11 February 2014
Our Ref: 5565P.10DK

**Sandon Point (aka McCauley's Beach)
Concept Plan and Project Approval Modification No. 4 (MP06_0094 and MP07_0032)
Responses to submissions and Preferred Project Report**

Figure 2: Exhibited Draft Wollongong LEP

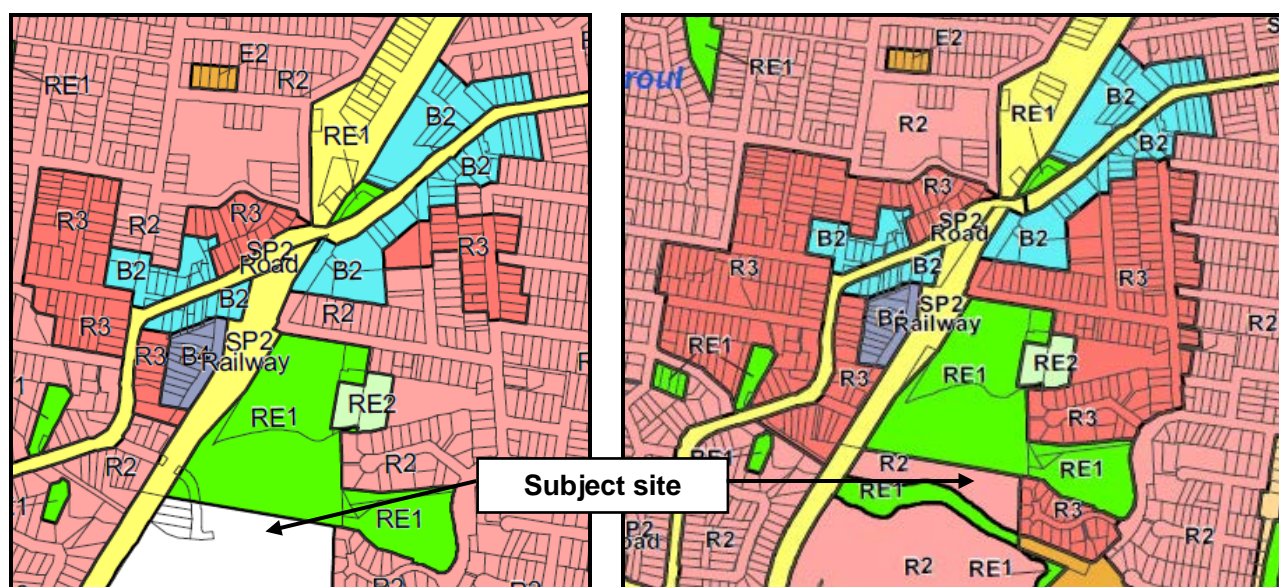
The Department has asked for additional justification for the change from apartment to residential lots having regard to the site's proximity to the station and town centre and implications for housing supply and choice.

Under Wollongong LEP 2009 there is other R3 zoned land around the Thirroul railway station town centre and B2 zoned land in the town centre (as illustrated in **Figure 1**) that is not yet developed. These zones permit residential flat buildings, multi dwelling housing and shop top housing. Therefore there are other opportunities for increased residential densities in and around the Thirroul town centre and close to public transport.

The draft Wollongong LEP which has been exhibited is proposing to expand the extent of the R3 zone as illustrated in **Figure 2** below. The current LEP shows the subject site as white (being subject to the MD SEPP). However the comparison below illustrates that the draft LEP is proposing to amend the zoning of the subject site to R2 – Low Density Residential.

| PROPOSED STAGE 6 LAYOUT PLAN | | | |

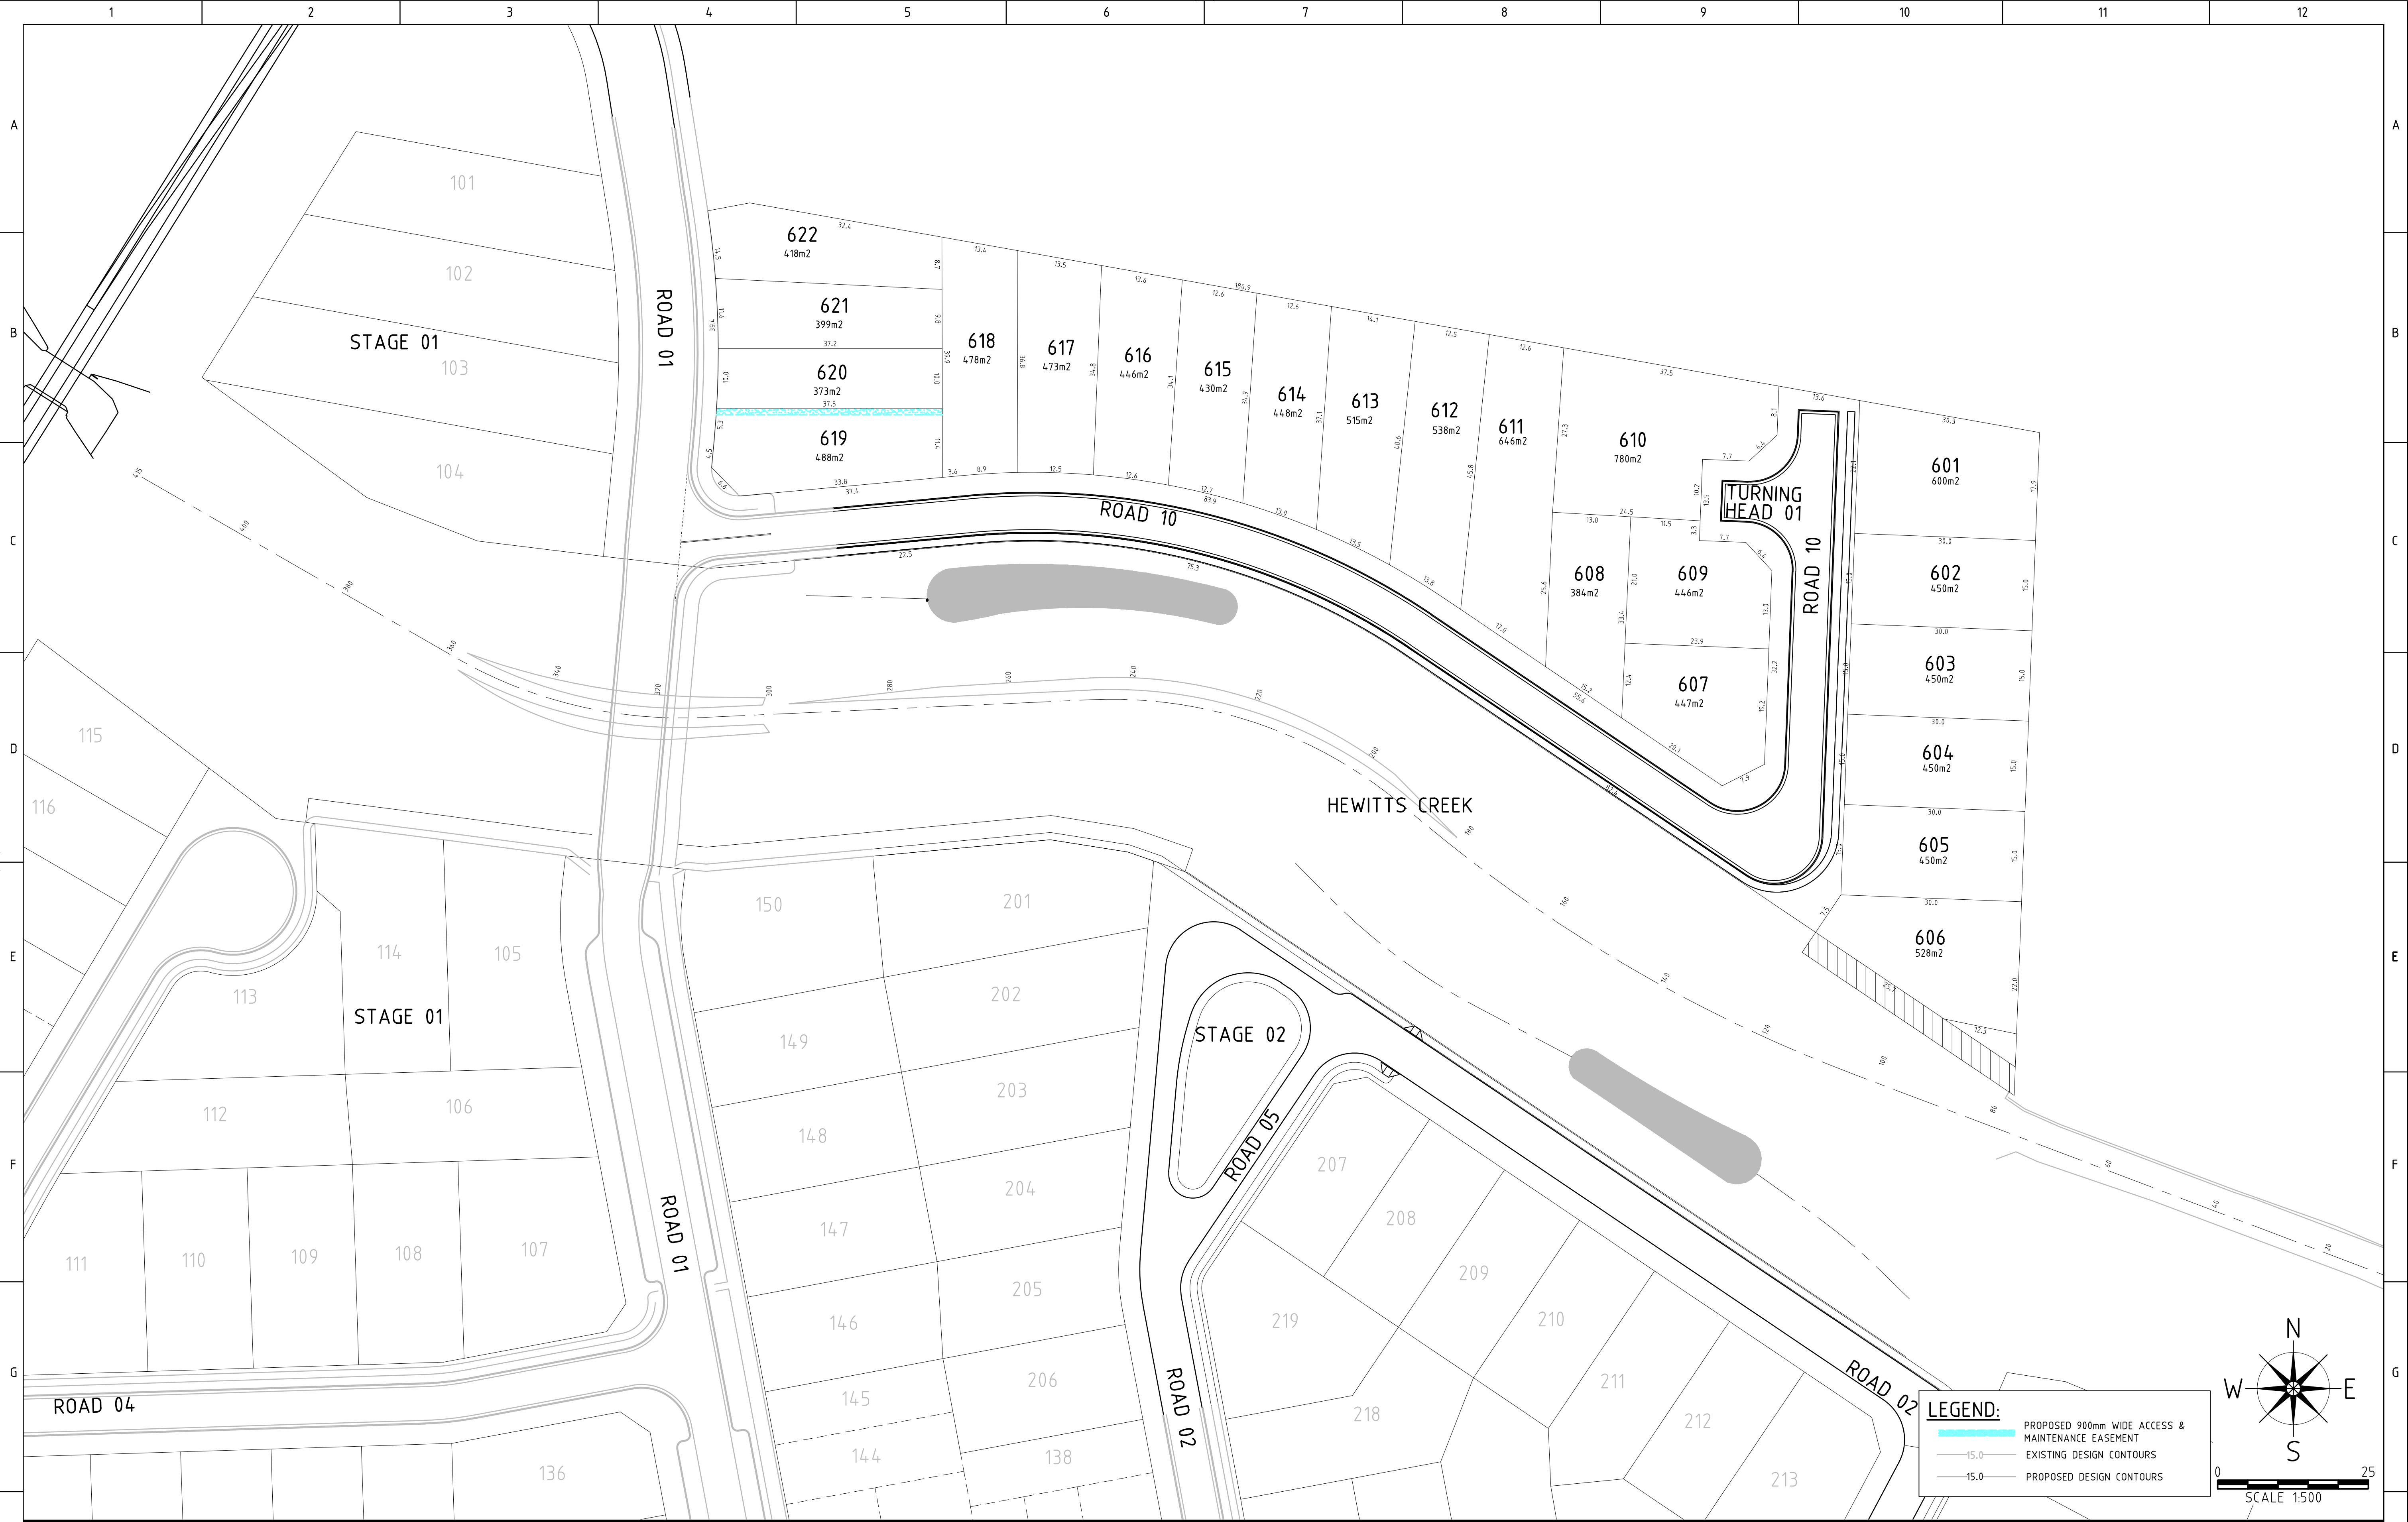
Building envelopes have been applied to each of these proposed lots to demonstrate that they are capable of being developed. DFP has been involved with other residential subdivisions in the West Dapto release area of the Wollongong local government area. Narrow lots of 10-11m width have been approved in certain locations and Council has accepted the narrow product lots. In the case of 10m wide lots, a zero lot line was proposed along one boundary in other approved subdivisions. It is proposed that the 10m lot have a zero lot line along the southern side boundary and therefore a 900mm wide easement for access and maintenance on the adjoining allotment will be necessary. The proposed subdivision plans have been amended accordingly and are provided at **Attachment 1**.

Lot 606 is not part of the subdivision or this s75W application and it is an existing lot that has already been registered. The additional drawing at **Attachment 1** shows Lot 606 for contextual purposes.

As noted above lot 606 is an existing registered lot and therefore is not shown on the subdivision plan. The additional drawing at **Attachment 1** shows Lot 606 for contextual purposes.

Arising from the review of the submissions it is proposed to make one minor change to the proposed modification. This is the inclusion of a zero lot line to proposed Lot 620 and the associated designation of an easement on proposed Lot 619 to allow for maintenance access. A copy of the amended plans is included at **Attachment 1**. The details of the s88B instrument will be provided with the subdivision certificate.

- a) no change
- b) no change
- c) no change
- d) no change
- e) no change
- f) no change
- g) no change
- h) no change
- i) no change
- j) no change
- k) no change
- l) A restriction as to user on the title of proposed lots 607-622 as indicated on Drawing SK11 requiring future dwelling houses to comply with the following built form controls:
 - (i) A maximum floor space ratio of 0.5:1; and
 - (ii) A maximum height of building of 9mThe definitions of floor space ratio and height of building are as per SEPP (Major Development) 2005.
- j) A 900mm wide easement on the title of proposed lot 619 for access and maintenance to benefit proposed lot 620 to allow for a zero lot line along the southern boundary of proposed lot 620.
